TDECQ, TECQ processing in IEEE 802.3db

(in support of comment #205)

V4.0 for comment on D2.0

IEEE P802.3db 100 Gb/s, 200 Gb/s, and 400 Gb/s Short Reach Fiber Task Force
TF Interim Teleconference, November 18, 2021

Figure 167-x

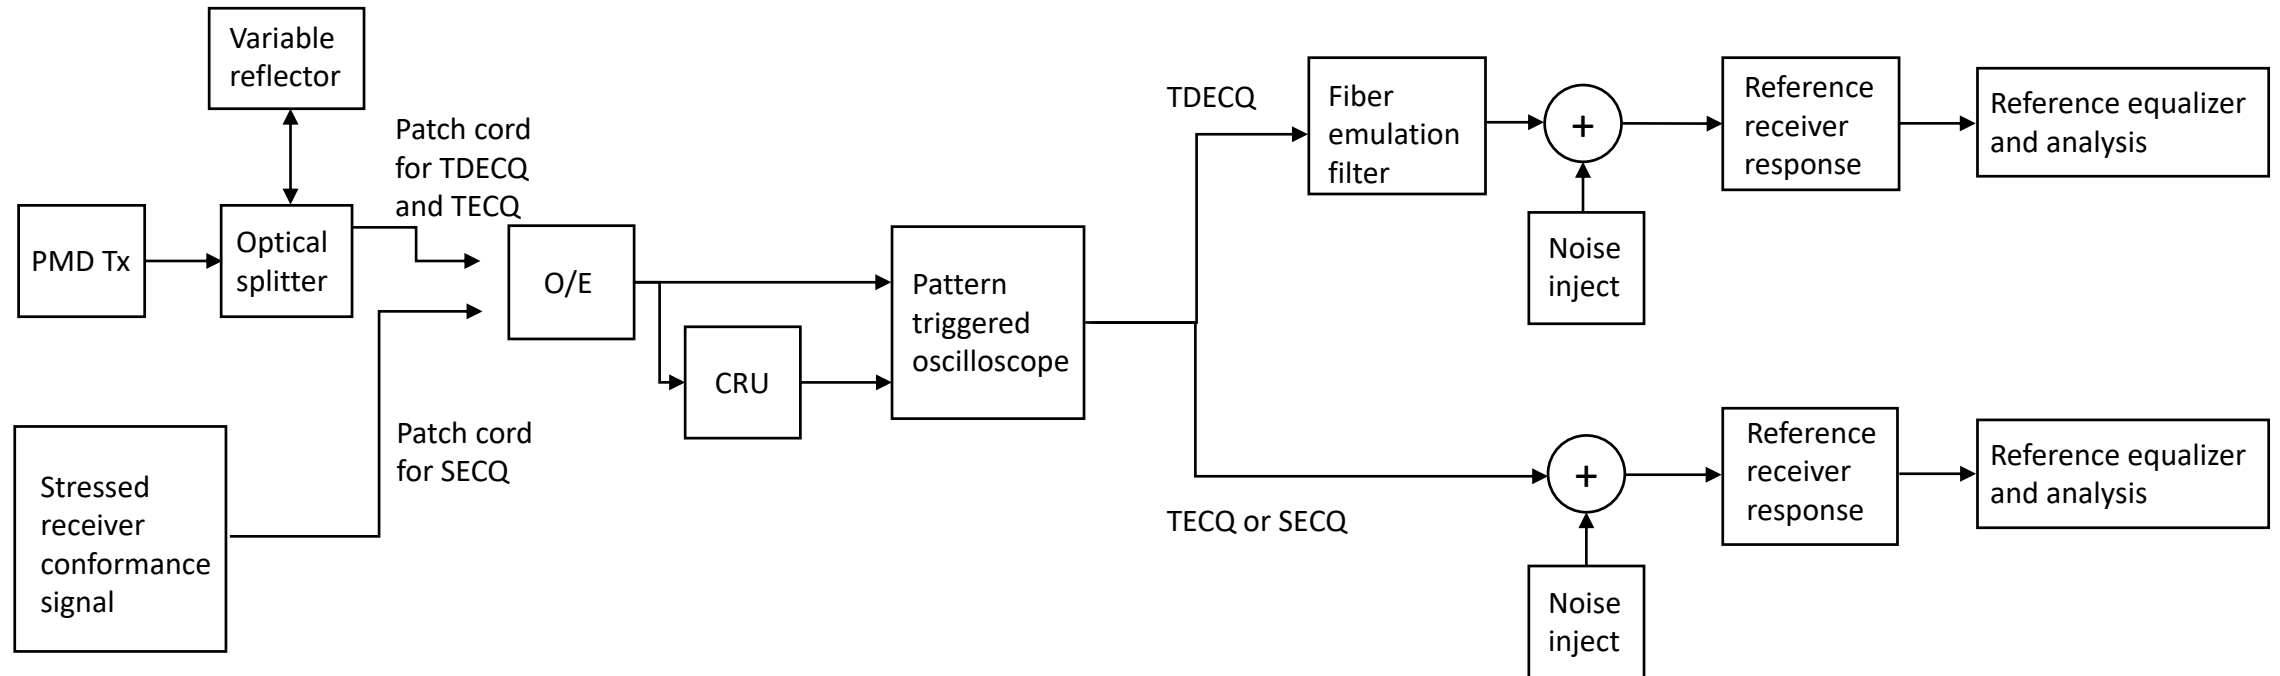
Adopt the style of Figure 121-4
